Reviewer 3

Review of manuscript sensors-3003165 Effect of biomass water dynamics in cosmic-ray neutron sensor observations: A long-term analysis of maize-soybean rotation in Nebraska by Morris et al.

Figure 5. (a) Plot of N_{pvi} , N_0 , BWE time series. (b) A bar chart of the irrigation and precipitation (mm) at site CSP1 in 2023 and the corresponding SWC time series. The same plots for all other years and fields can be found in Supplementary Materials.

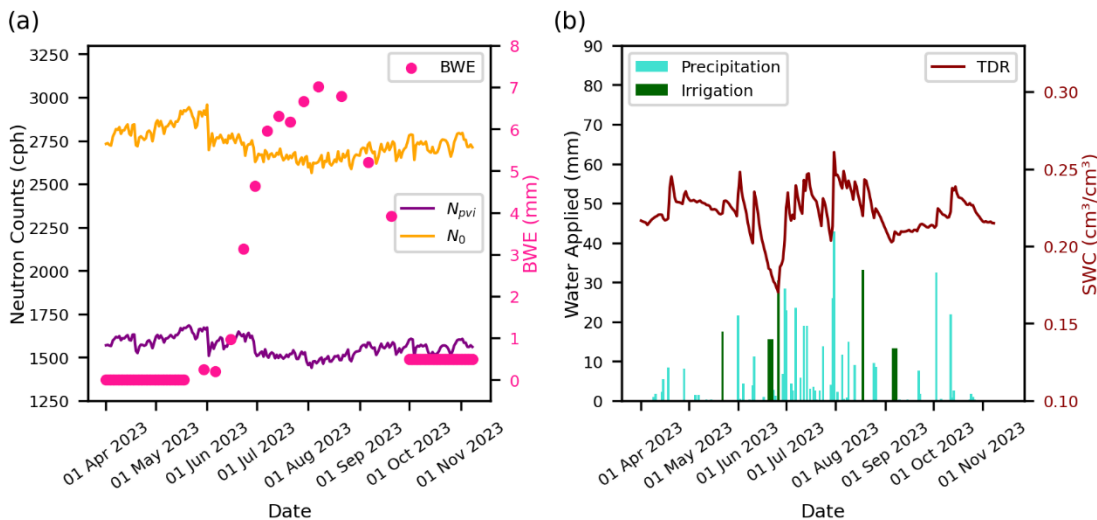
I appreciated the decision to show one year and one location as example (Section 3.1) and then the overall results (section 3.2 and Figure 7). The year selected is however the 2020 where only TDR observations are available. The comparison to the gravimetric is shown later in section 3.3. I suggest the Authors showing first the results of the year where you have also the gravimetric samples and discussing the differences between using TDR and using the gravimetric. This would help understanding the results and would strengthen the use of TDR over all the years.

Figure 4b shows a remarkable drop in TDR observations in April. Can this be explained or rather a sensor malfunction? This dynamic also affects the N_0 in figure 4a but might be considered an error. I suggest a quality check of the TDR data before looking at N_0 and BWE relation. CRNS SWC could also be added and discussed in Figure 4b. Please also clarify if this TDR time series is the average of all the sensors (location and depth) within the field.

Figures 4, 5, and 6 were changed to have CSP1 2023 data presented, rather than 2020. These can be seen as the new figures 5, 6, and 7 (Lines = 319, 344, and 364 respectively) in the revised manuscript, or below.

With the figures changed prior in this review, the drop in TDR observations in April is not as severe. In the CSP1 2020 figure, this severe drop in TDR observations was likely due to dry winter and spring seasons in combination with warm spring conditions. Irrigation in CSP1 in 2020 was performed in April.

The only other year this occurred was in 2021. Irrigation occurring this early indicates extremely dry conditions, which affirms the severe drop in TDR observations. A more likely source of this drop is sensor error. In early 2020 routine maintenance could not be performed on TDR sensors due to the onset of COVID restrictions, so sensor error is likely. These sensors were able to be serviced around the time of the TDR rebound.

The new figure does have a shift in TDR values present, and this is addressed as follows: “There is a shift in June, which is likely due to sensor error, which was then repaired.” (Line 342 – 353)

Add line was added to the figure caption to clarify that this is the average of all TDR sensors in the field, after the 10, 25 cm weighting was applied: “The TDR values were weighted with the 10 cm sensor having 75% contribution and the 25 cm sensor having 25% contribution. The averaged values of all TDR sensors in the field was used to plot the line.” (Lines 322 – 324)

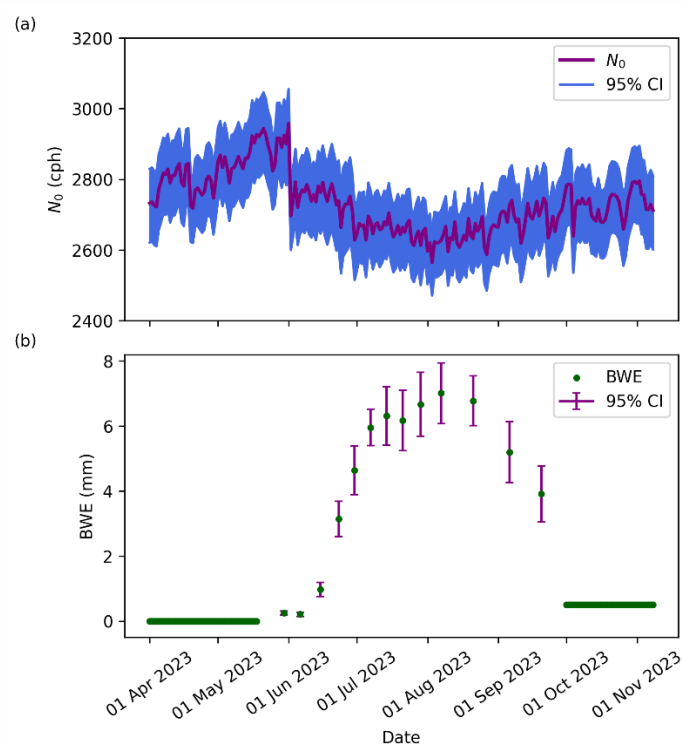
Figure 5. Am I wrong or these plots show the same as figure 4a but with bands? I think the figures are redundant and I suggest to rather keep only one, e.g., to show in figure 4b the time series as in figure 5.

In Figure 5 I see that after harvesting BWE remains higher than zero, but I did not find information about it in the manuscript. Please clarify.

These figures do show similar items. However, the main purpose of Figure 5 (now Figure 6 in the revised manuscript) was to show the error ranges on the N_0 and BWE measurements. With the error ranges included in Figure 5a (formerly 4a), the figure becomes unclear and difficult to understand. Another benefit of Figure 6 is that it highlights the timing of N_0 and BWE with one another.

This information was not addressed in the manuscript. An explanation for this has been added: “After harvest, BWE remains higher than zero to account for the plant debris, like corn stover, on the surface. Most of this debris degrades over the winter and is completely removed with soybean harvests the following year.”

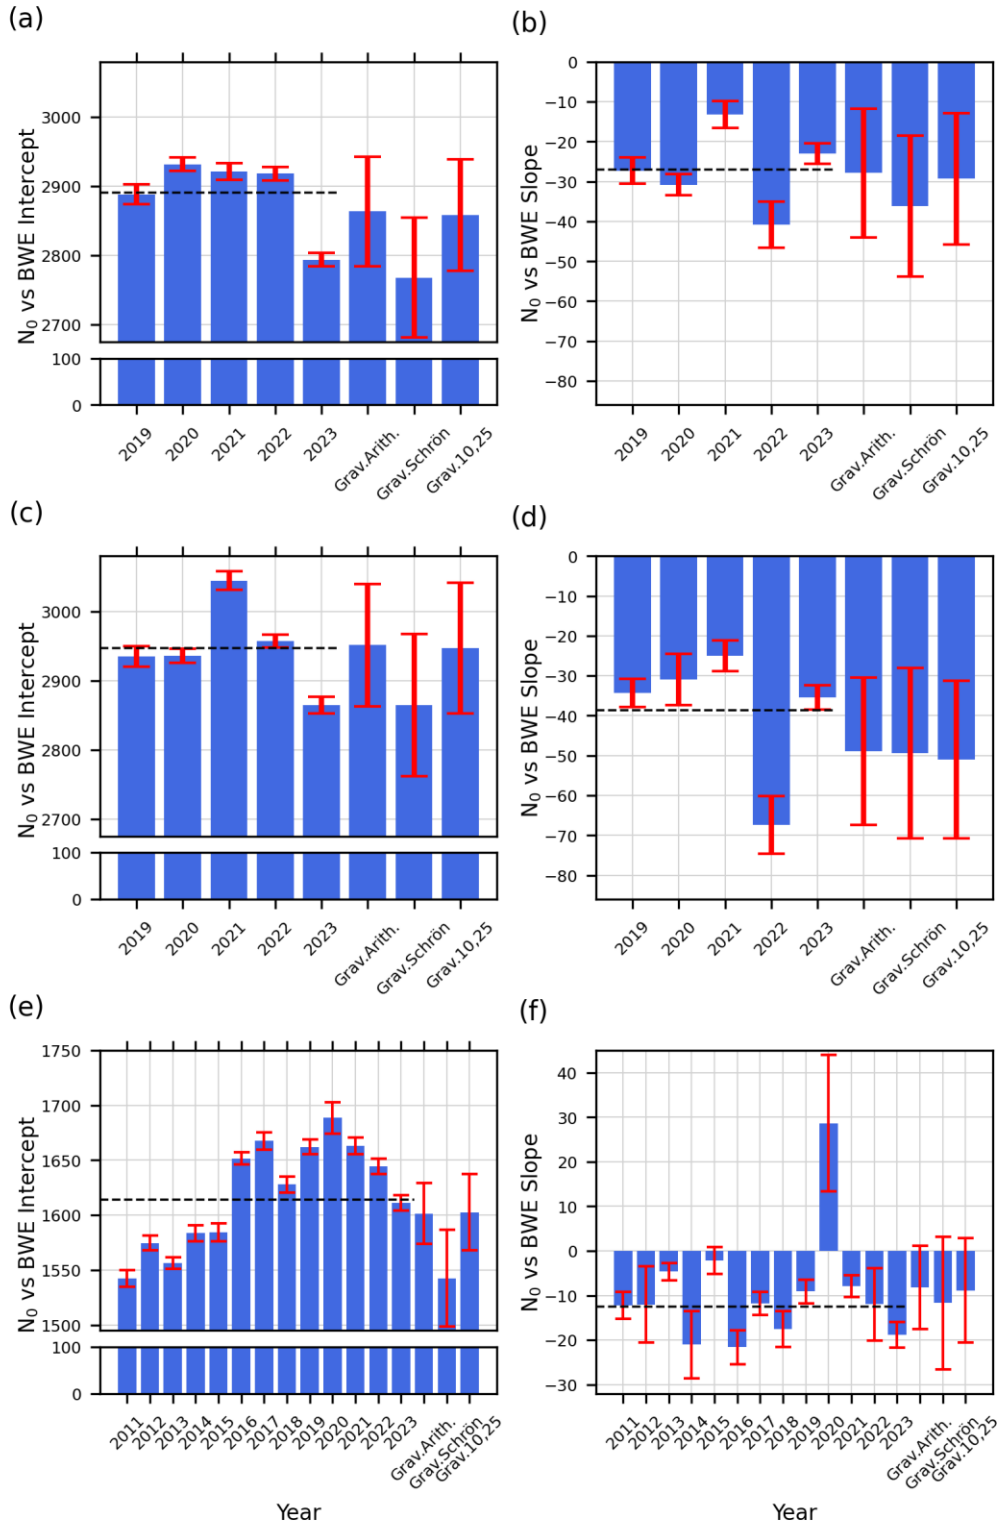
L356 – 361. Hard to read and follow this text. Better to summarize the message rather than writing all the years

L381. At CSP3, there seems to be a systematic shift to higher intercept values from 2016 to 2023. Could you explain that? Anything about the time changes of organic carbon? See comment above.

We agree that there does appear to be a systemic shift to higher intercept values; however, we do not have a physical explanation of why this happens. The soil organic carbon does change slightly, but as mentioned in a prior comment, most of this is removed every other year when soybeans are harvested. It is unlikely that a small change in the organic carbon would have this sudden and significant of a change on the intercept. In short, we do not know why this happens, but it should be investigated.

This was addressed as such in the revised manuscript: "To the author's knowledge, there is no clear physical explanation for this shift. One potential source of this change is an increase in soil organic carbon; however, as previously mentioned, most of this is removed every two years. While this is within the range of the overall average, this area deserves additional investigation." (Lines 436 – 440)

We also note that while there is a shift, it is not extreme, as it falls within the 5% error range of the overall average TDR value for this field. A black dashed line was added to Figure 9 (formerly Figure 8) to show where the global averages of each slope and intercept occur (Lines 401 – 405).

This was also addressed in writing in the manuscript: “All within-field intercept values are within 200 counts, which is within 5% error range of the average TDR value.” (Line 433 – 435) and “Within all three fields, the confidence intervals overlap between several years, indicating they fall within one another’s error ranges (please see Figure 9 to view confidence intervals). Most TDR slope values within each field are within 10% error of the average slope value for CSP1 and CSP2. This same consistency likely is not seen in CSP3 due to more variability in measurements.” (Line 417 – 421)
